1966 - 1967 Corvette: Service Bulletin: Crankshaft to Water Pump Drive Belt Failure

Subject: Crankshaft to Water Pump Drive Belt Failure
Model and Year: 1966 - 1967 Corvettes with 427 CU. IN. Engine and Air Conditioning
Source: Chevrolet Service Technical Bulletin
Bulletin No: 67-T-26
Section: VI
Date: Sept. 26, 1967

FIG. 1

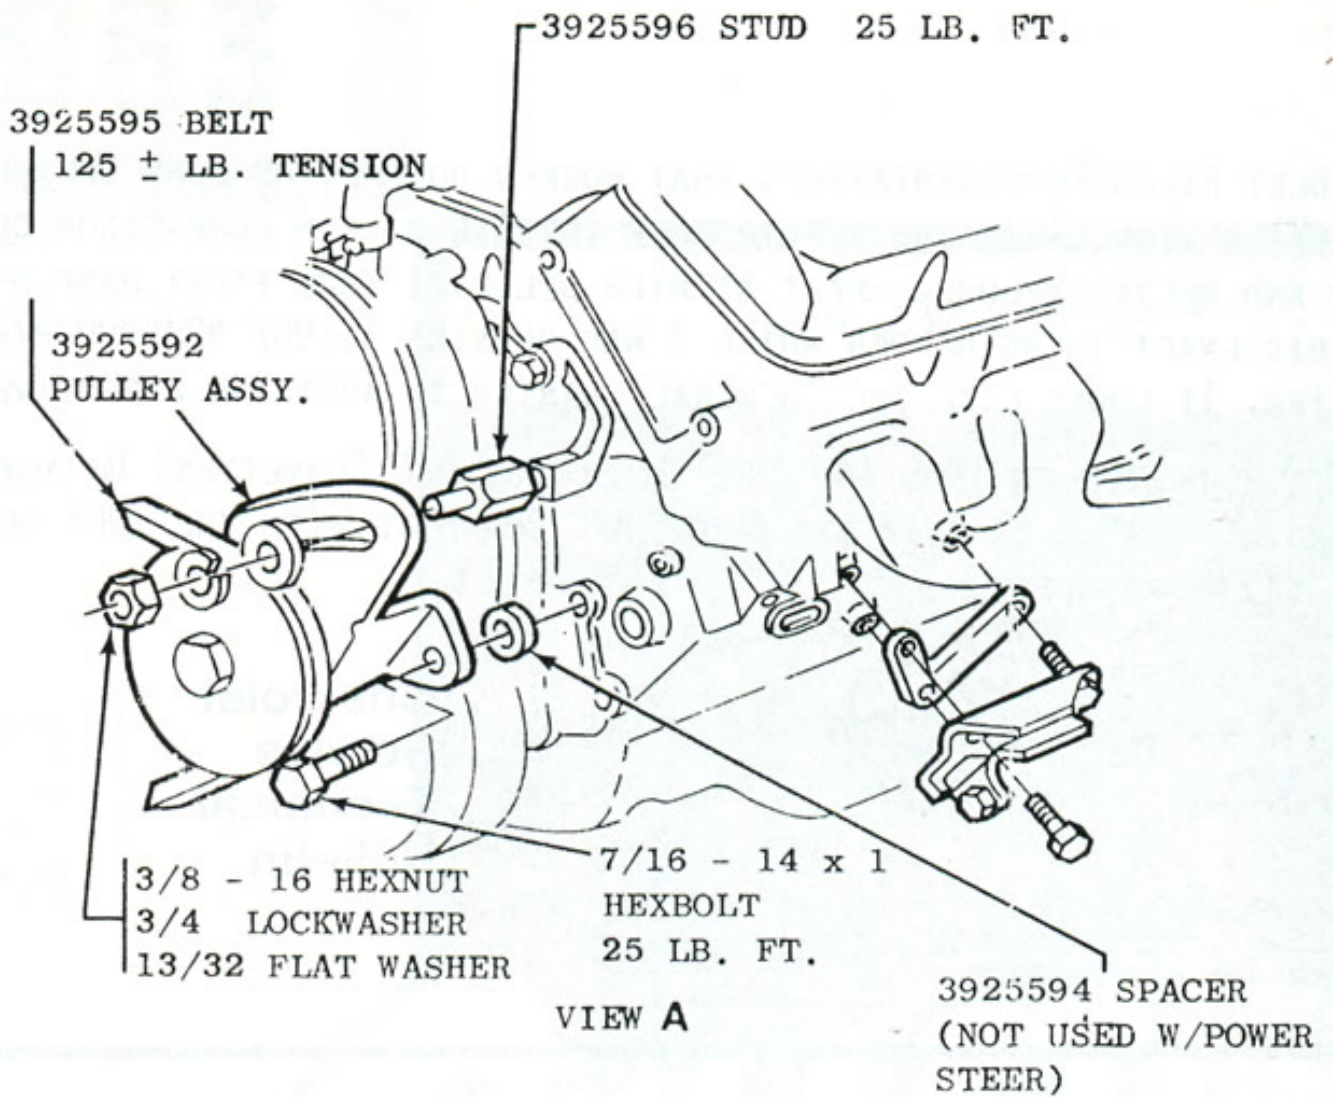
Reports have been received of crankshaft to water pump drive belt failures on 1966 and 1967 Corvettes equipped with 427 cubic inch engine and air conditioning. The belt failure occurs when the air conditioning compressor stalls under high head pressure after extreme hot soak conditions. With the compressor stalled, the water pump and the drive belt between the crankshaft and water pump also stall. As the crankshaft pulley continues to rotate, the crankshaft to water pump drive belt fails due to overheating and wear.

To permit belt tension adjustment between the crankshaft and water pump, 1968 Corvettes equipped with 427 cubic inch engine and air conditioning will incorporate an idler pulley shown in Figure 1.

In service, a similar idler pulley and longer drive belt can be installed to permit belt tension adjustment and correct the condition of belt slippage and wear. Parts information and installation instructions are illustrated in Figure 1

3925595 BELT
125 ± 5 LB. TENSION
